ADDENDUM NUMBER 1:

Re: PD 16-17.097 Re-Bid Alger-Sullivan SHIP Replacement Housing

This Addendum Number 1 provides for the updates which follow on the next page. Additionally, questions transcribed from the pre-solicitation conference have been answered and included below, as well as a revised outline of specifications, and three (3) new drawing sheets for 416 Front Street (pages A1, A2, and A6).

Date:
09-01-17
Project No.
1816
Sheet No.
House 416
A2

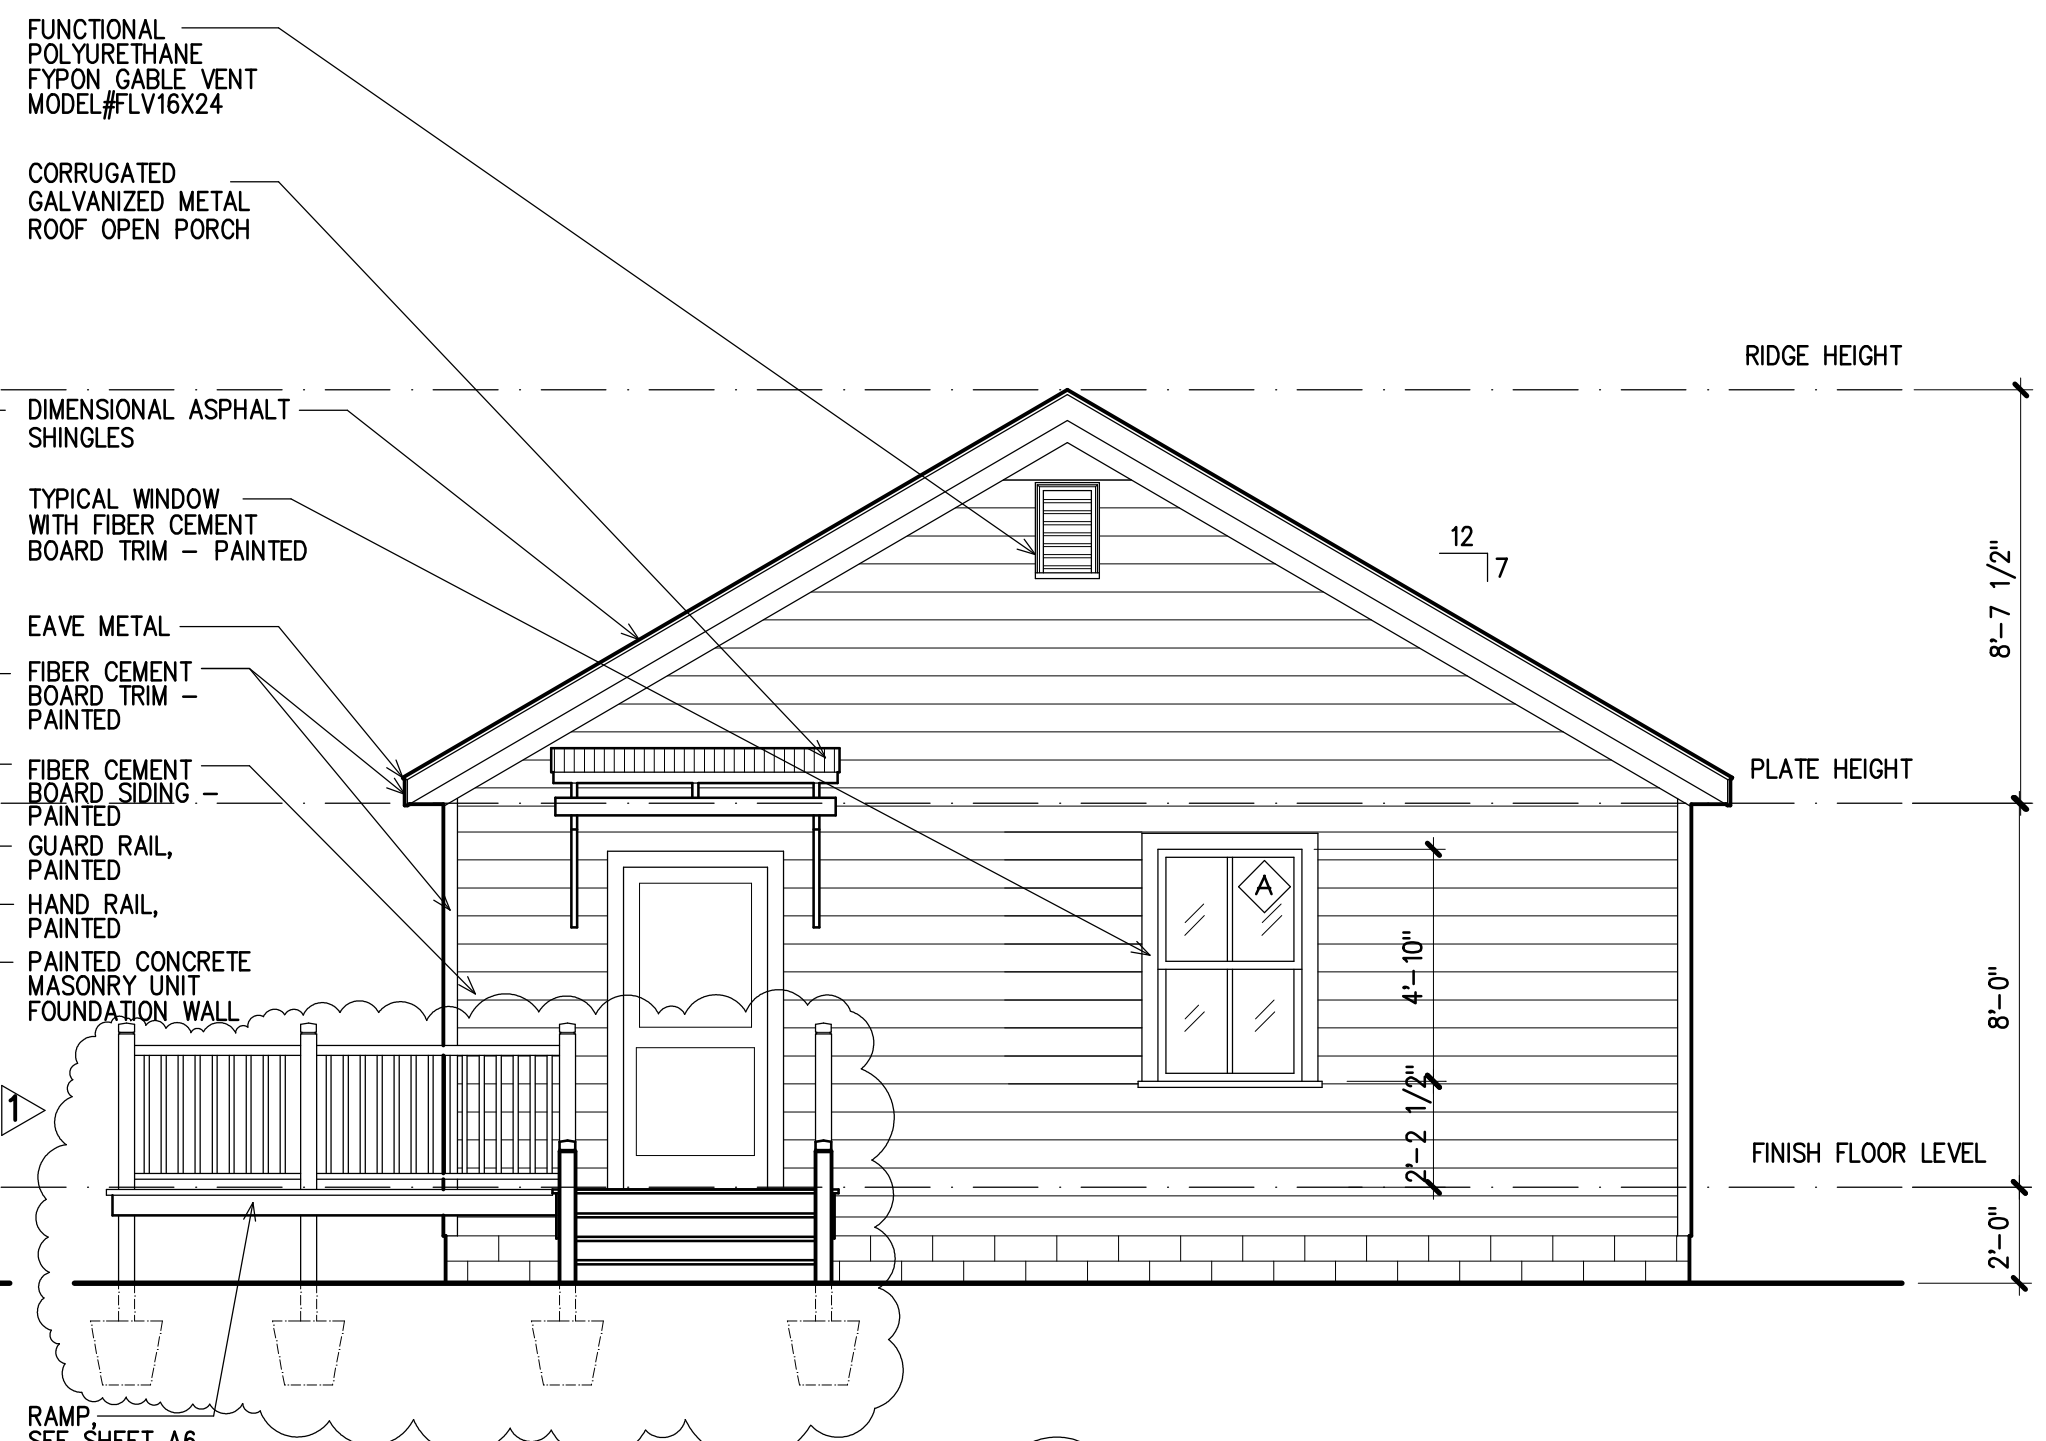
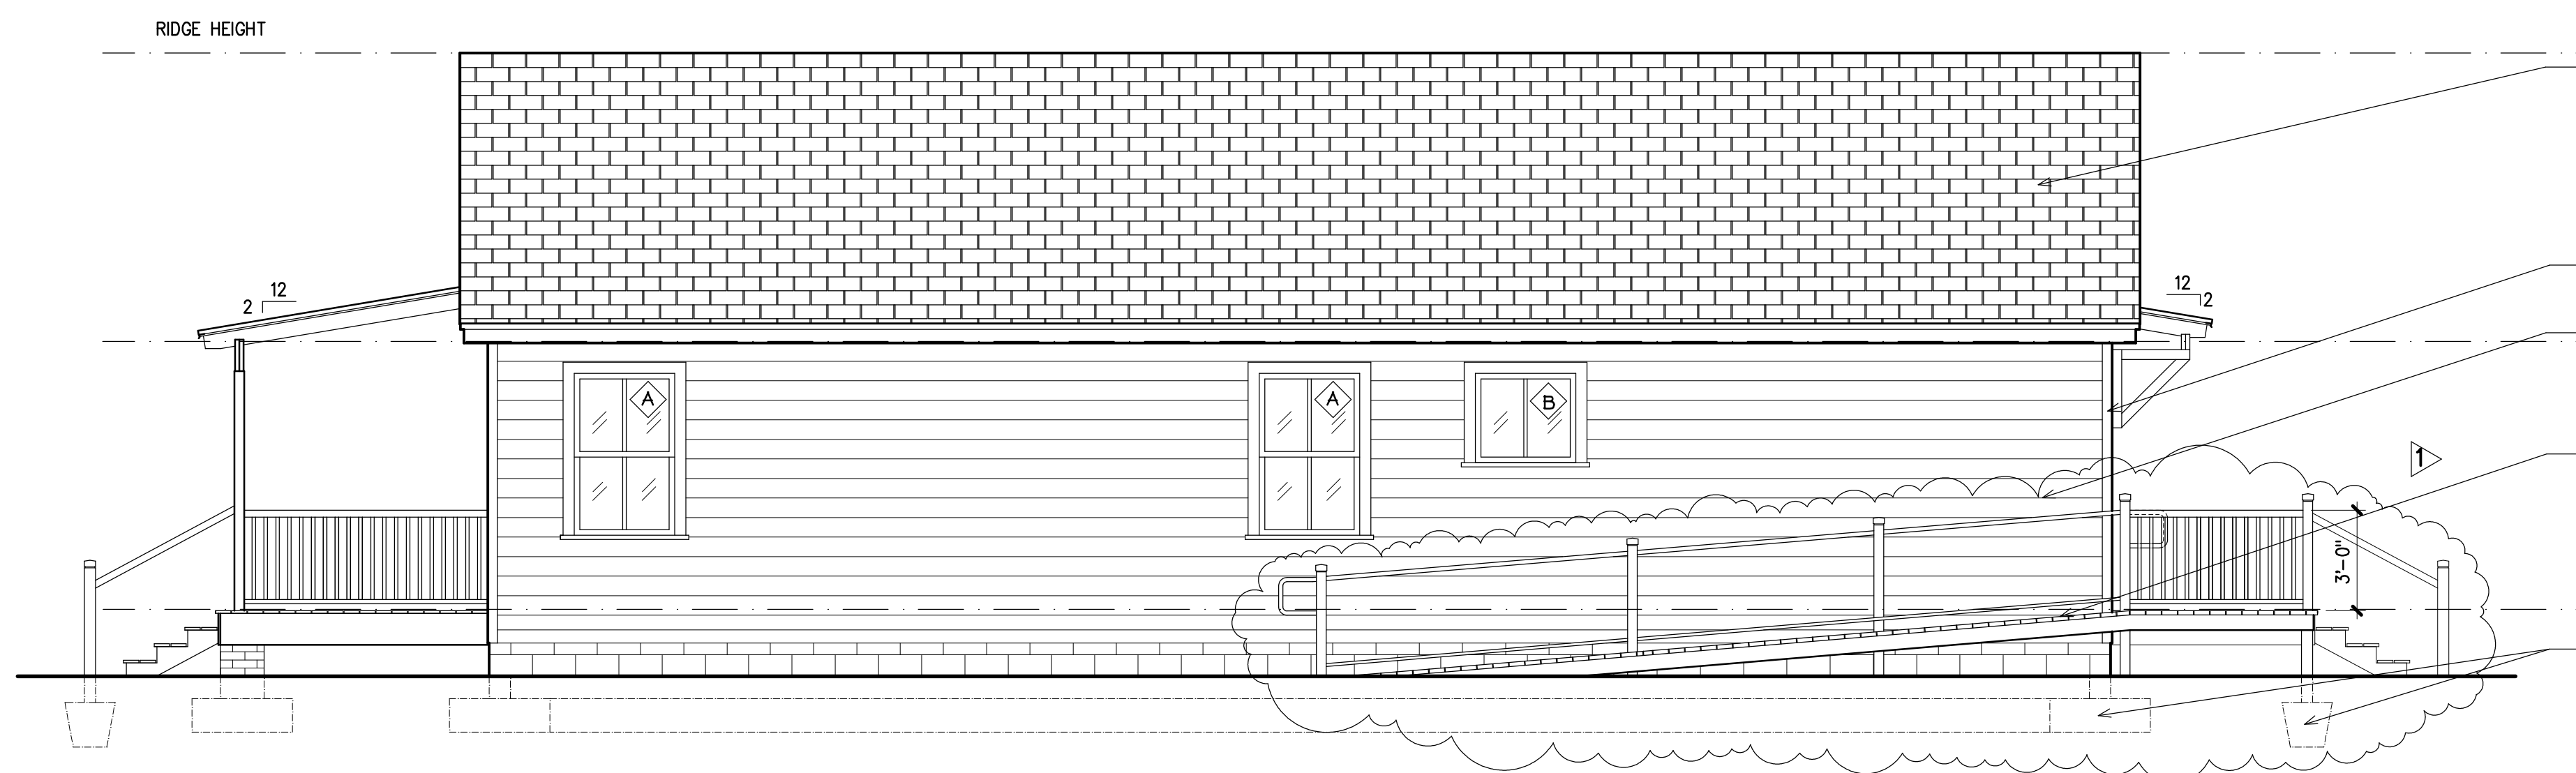
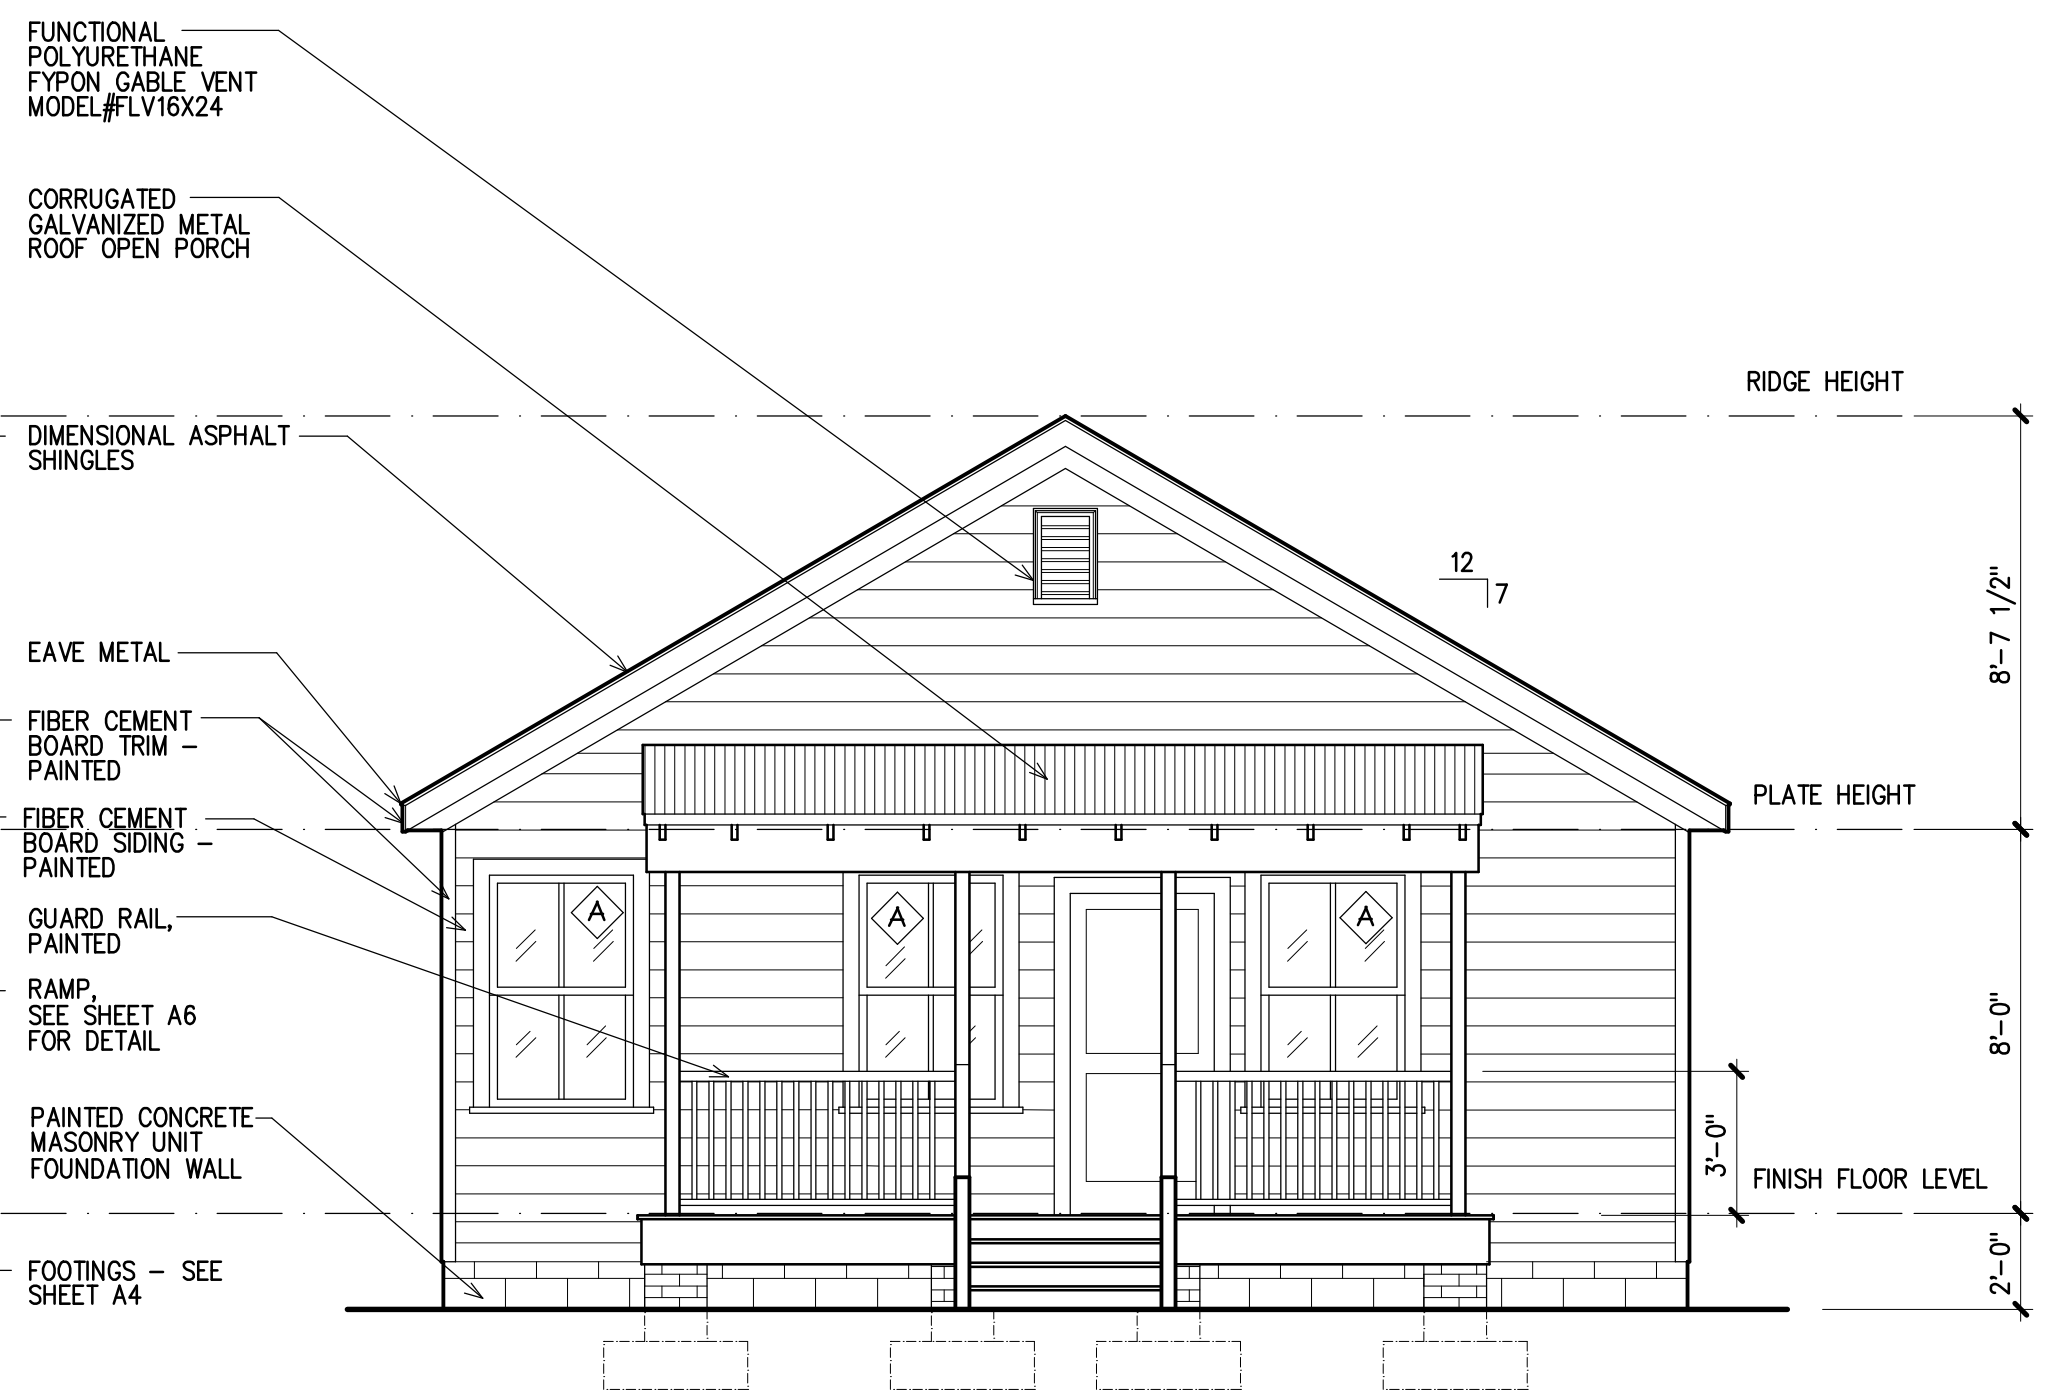
8. All reference to interior trim to be wood, either 1x4 or Contractor's standard casing trim.
- b. Refer to sheet A2, Unit 416 only.
 1. See revised Back and Side Elevations showing ramp.

10-19-17 Ramp Railing
